**PAUL HALAJIAN
ARCHITECTS**

ADDENDUM

PROJECT: **Clovis Landmark Square
Senior Activity Center and Transit Center**

ADDENDUM#: **03**

PROJECT NO. CIP 15-03
SHEET NO. 7 OF 24

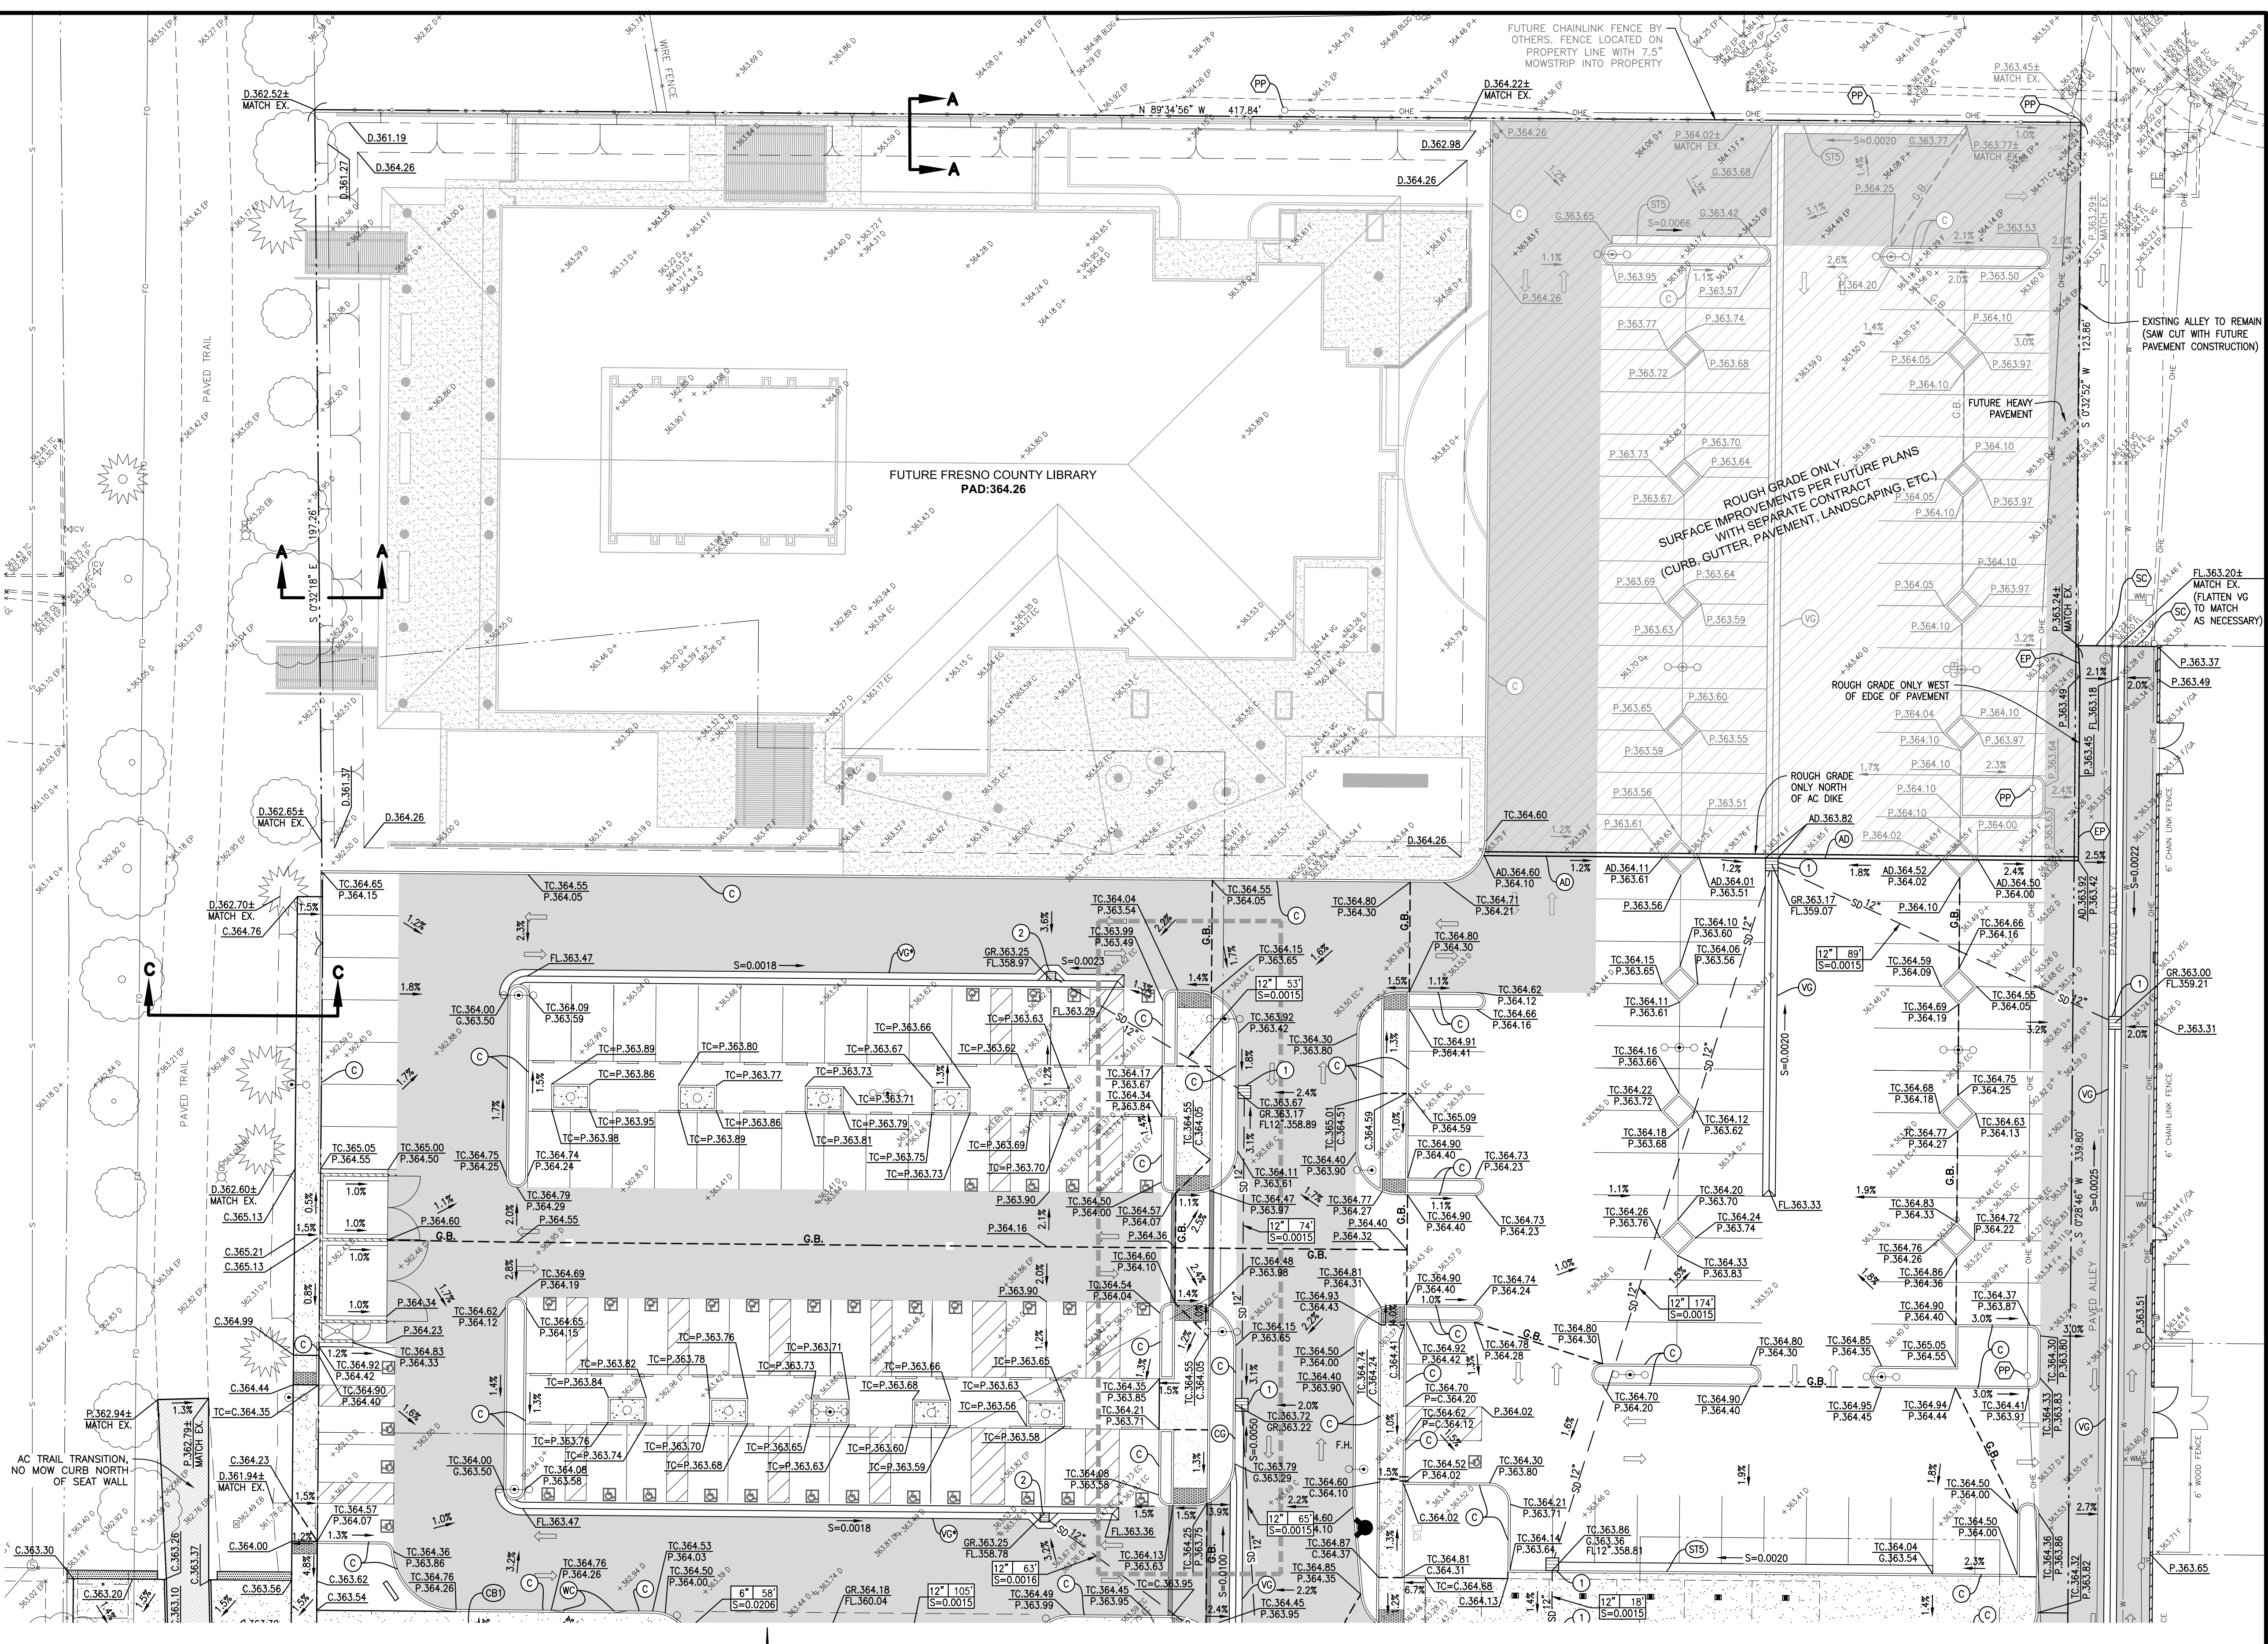
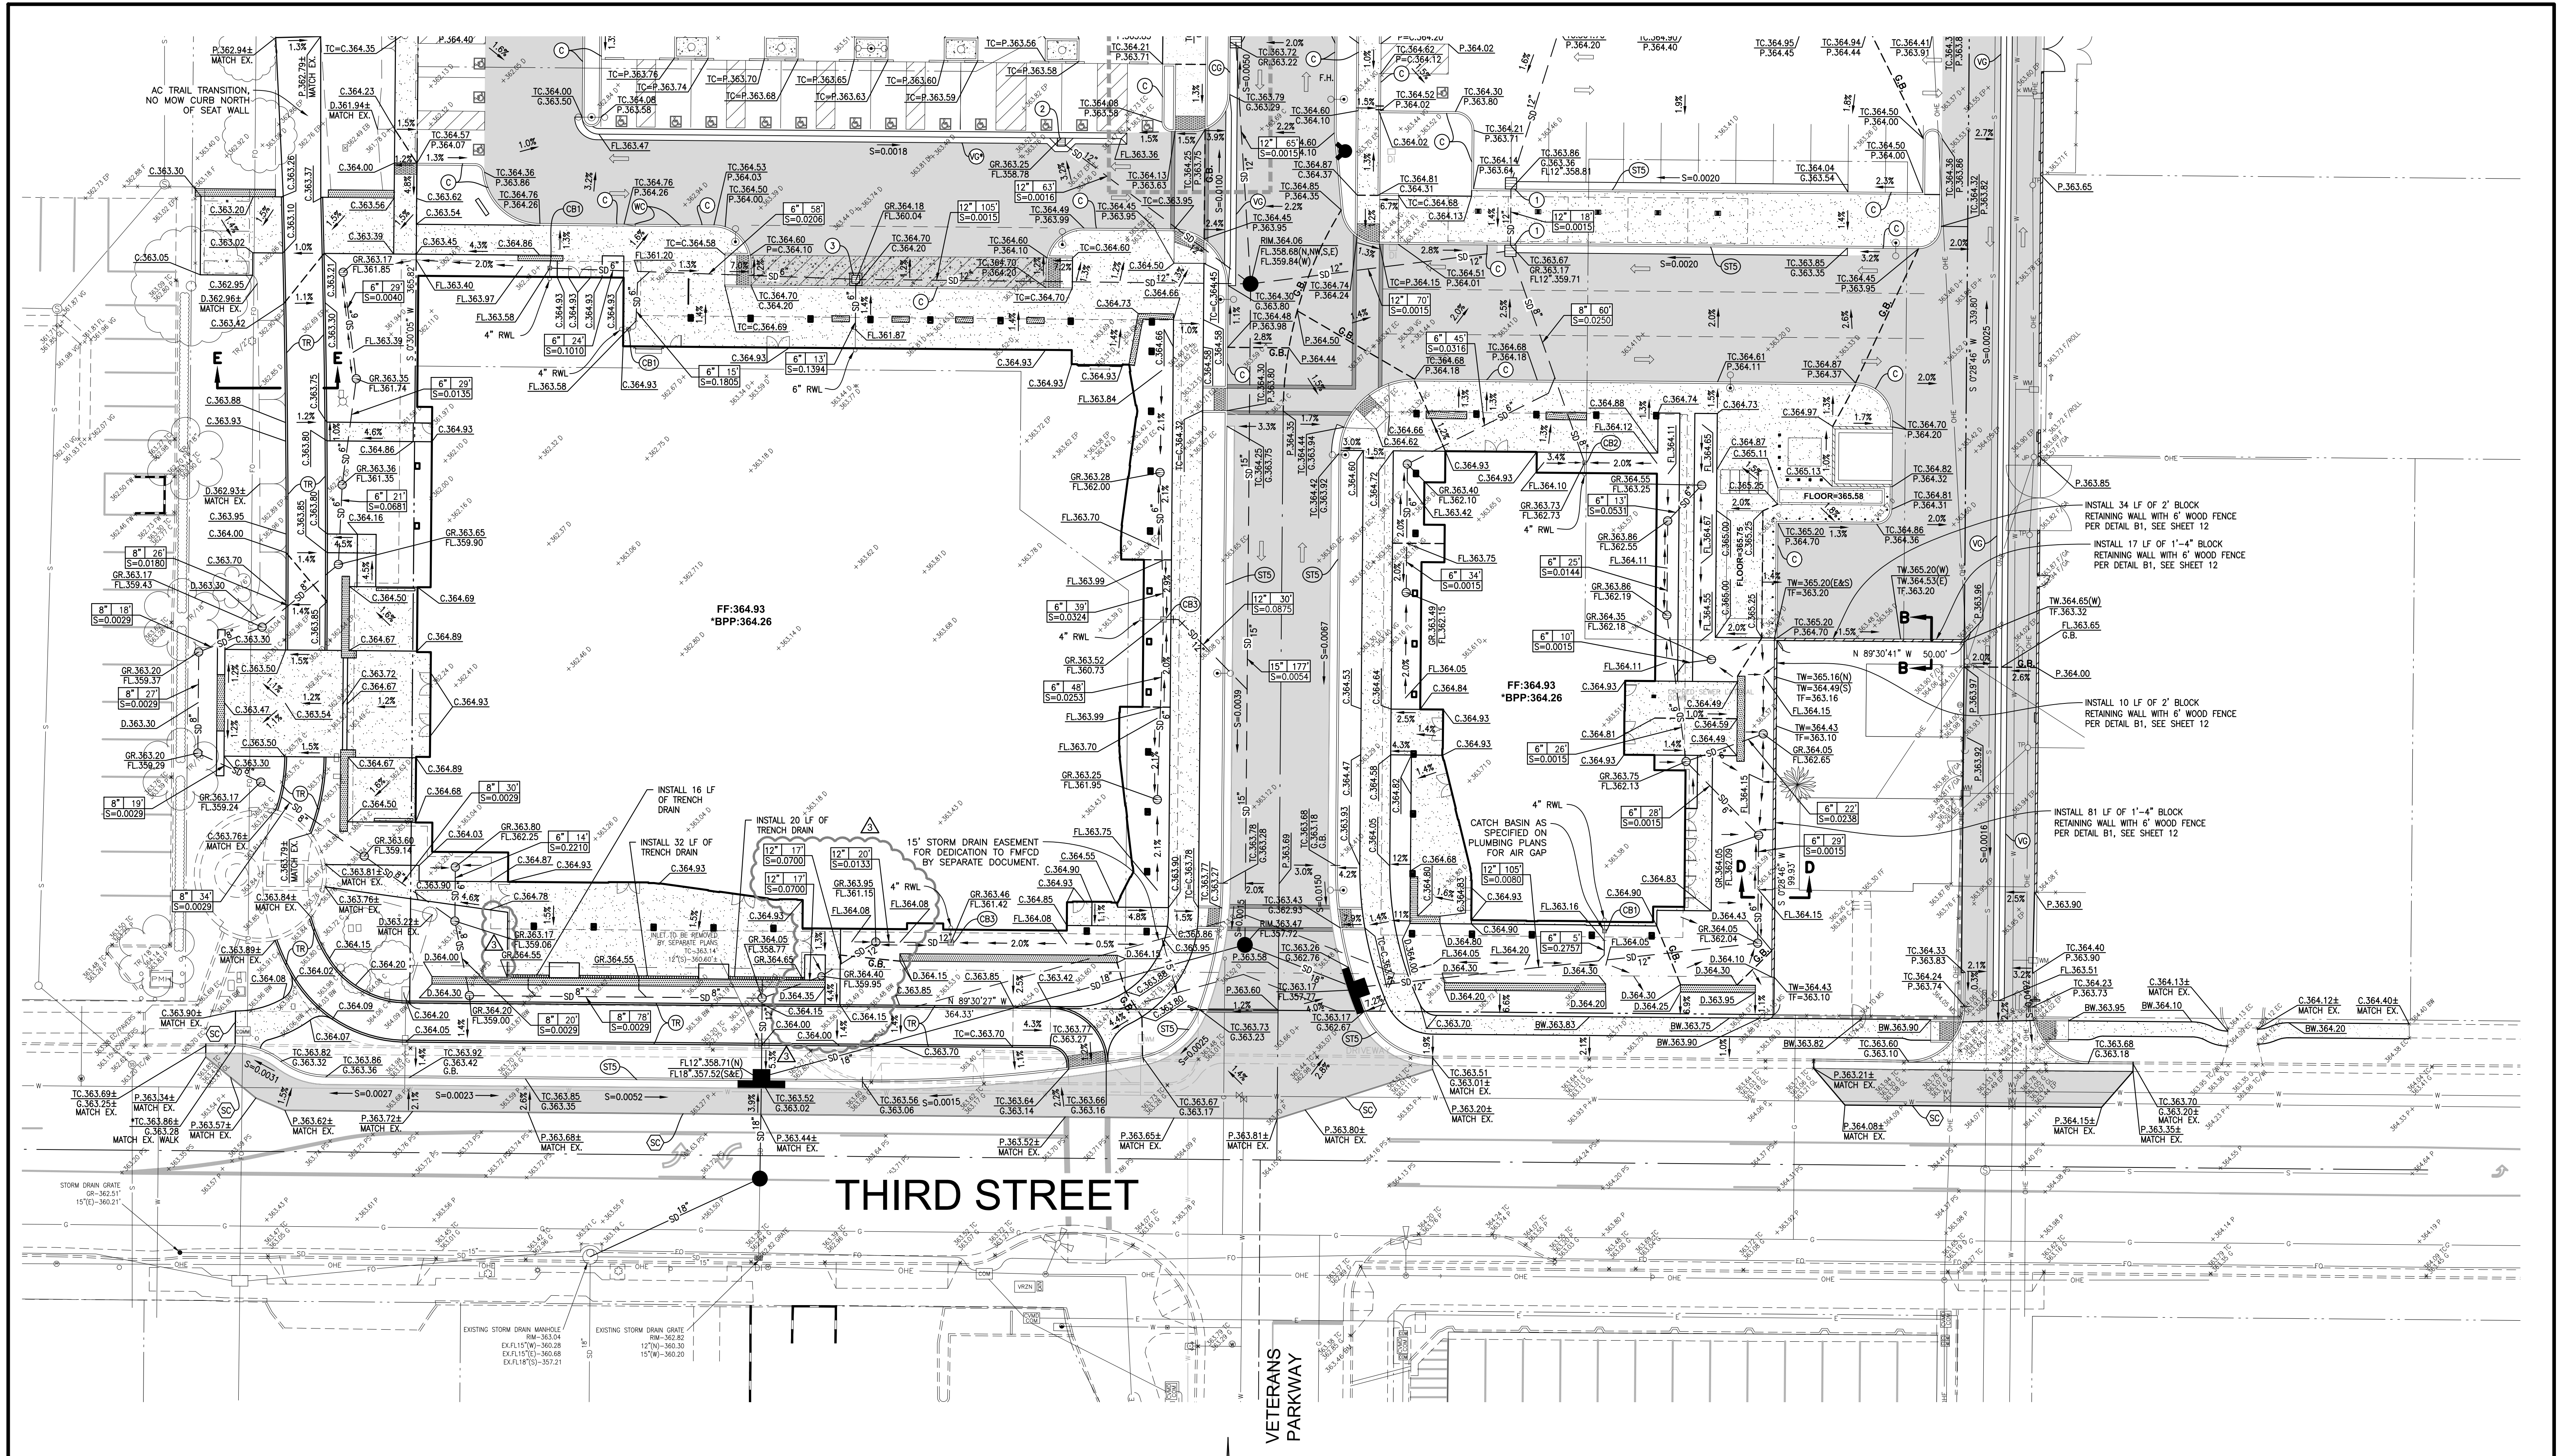
Reference: SHEET 7 THROUGH 11 – ON-SITE IMPROVEMENT PLANS.

- a. **RFI Question:** I am having a hard time reading the Grading Plans/Paving plans on the 'city of clovis, planning and development plans'. Where can Contractors access a clean/Original PDF copy of these plans to assist in accurate take off's?
- b. **RFI Response:** Refer to non-scanned grading & paving plans (Sheets 7-11) attached within this addendum for clearer resolution for Bidding Purposes only.

- i. 'City of Clovis, Planning and development department; Grading Plan north (Sheet no. 7 of 24)' designates the carpark and Future Fresno County Library as 'Rough Grade only', however sheet AD1-F100 shows fire line going to the new library. Please confirm if we are to include for this. If not, please confirm how and where we are to terminate the scope in this area.

- i. Refer to All Site Plans: Scope for this portion of the site as follows:
 1. Improvements on the "Future Parking Area" on the north portion of the parking field shall include the following: all underground improvements, demolition, clearing & grubbing and rough grading as specified in the construction drawings and specifications. It shall exclude pavement section (AC & aggregate base), valley gutter, curb, landscaping, landscaping irrigation system, light poles & foundations and all other surface improvements.
